Reference: PG&E Gateway Generating Station (00-AFC-01C)

Subject: PETITION FOR INSIGNIFICANT PROJECT CHANGE TO PLANT FACILITY

PETITION FOR INSIGNIFICANT PROJECT CHANGE
AT
GATEWAY GENERATING STATION (GGS)

SITE ARRANGEMENT PLAN

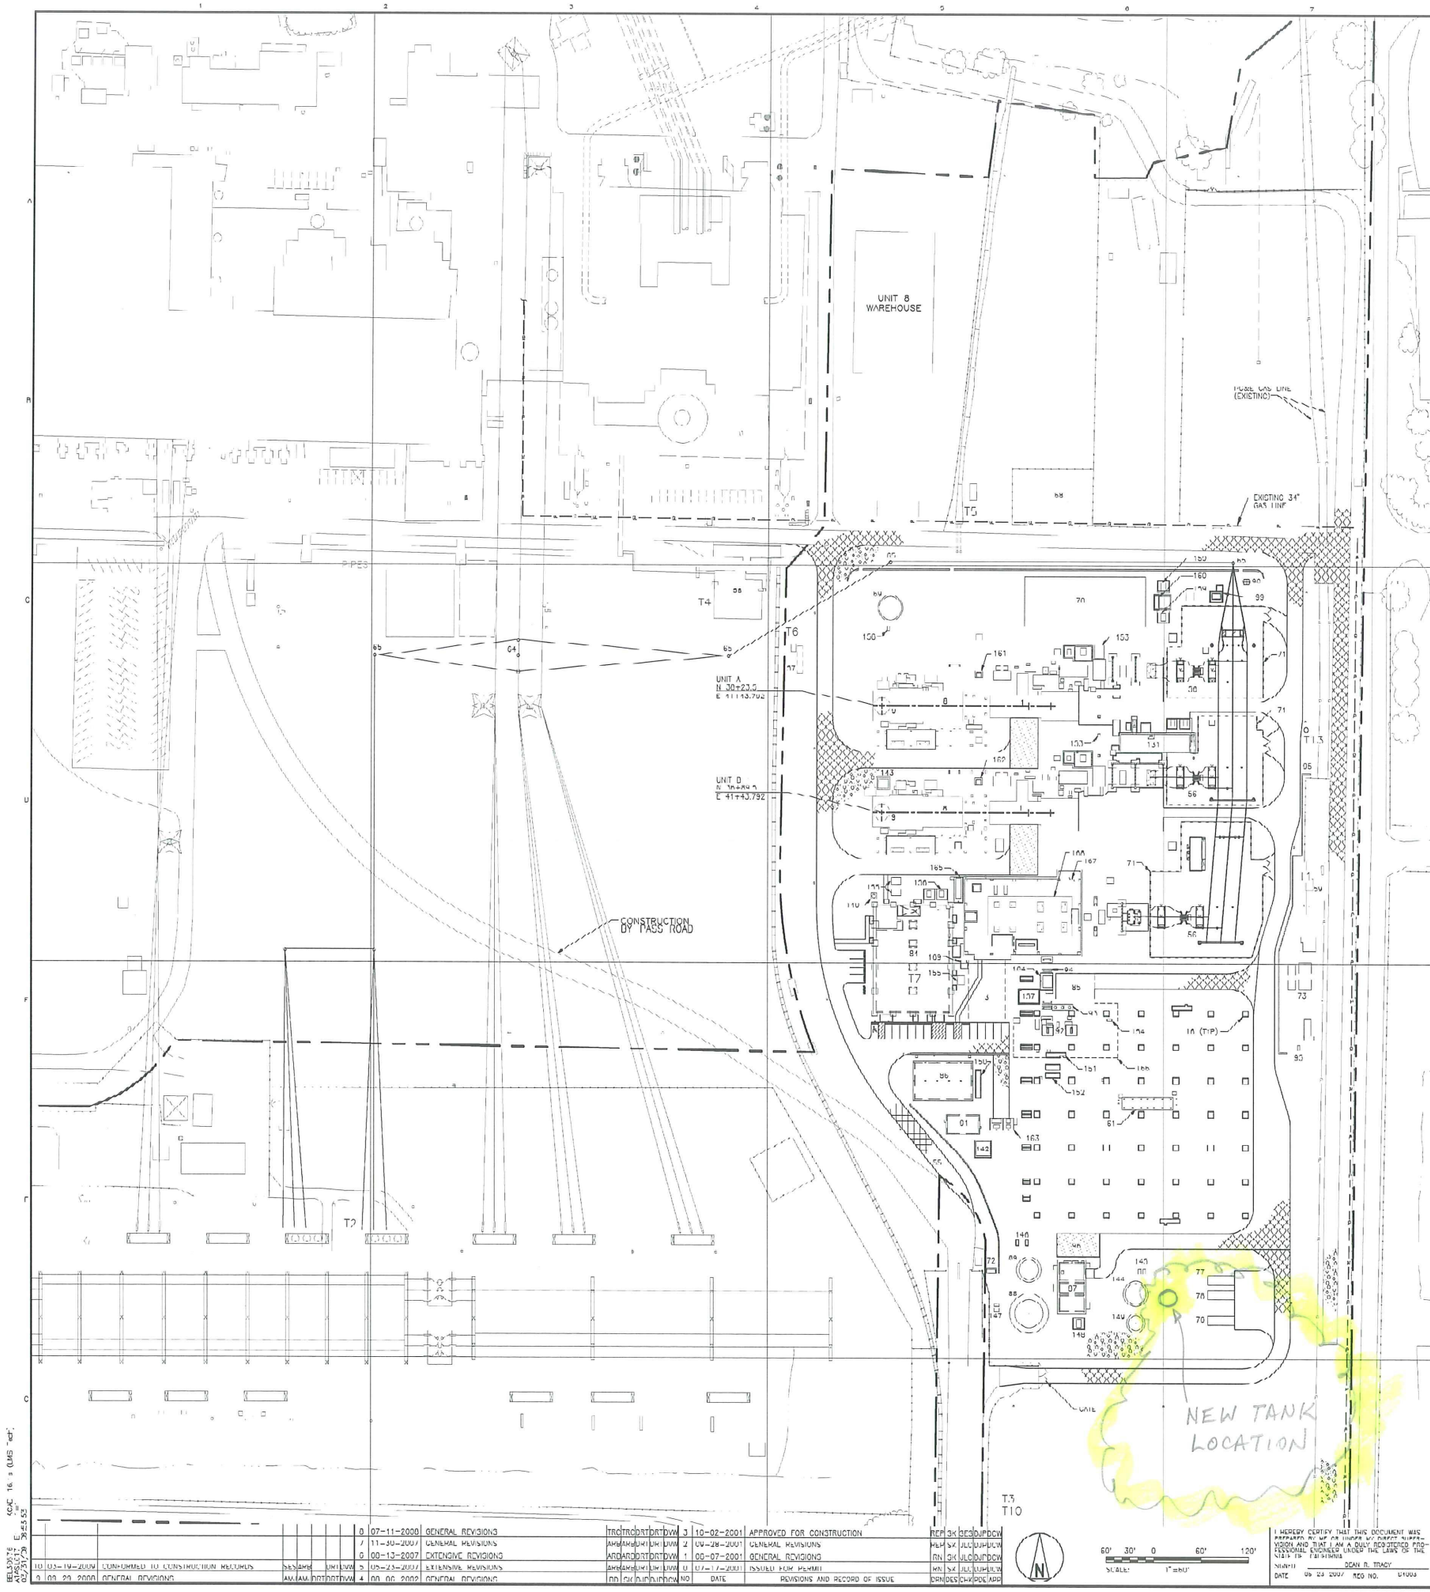
a. **Description of Modification**: This modification proposes to install a new nominal 40,000 gallons bolted carbon steel storage tank, which is the same specification for the existing waste water storage tank at the facility. The proposed tank will be used to contain the additional volume of reclaimed water produced during the increased frequency of start-up/shut down activities. This modification also includes the installation of additional forwarding pump, valves, and interconnecting pipes. The new tank will be located near the existing 100,000 gallon reclaimed water tank (See attached Facility Layout.). Also attached is the Design Drawing for details on equipment specification.

e. **Analysis of the impacts the modification may have on the environment**: The additional tank will be installed next to the existing tanks in the facility, and will have no significant adverse impacts on the environment. This tank is equal in specification to the smallest tank in the tank farm area. The storage tank is above ground, and normally will have no leakage. As a result of the increased retention capacity, the facility will further reduce the overall amount of water usage and discharge, reducing our environmental impact.
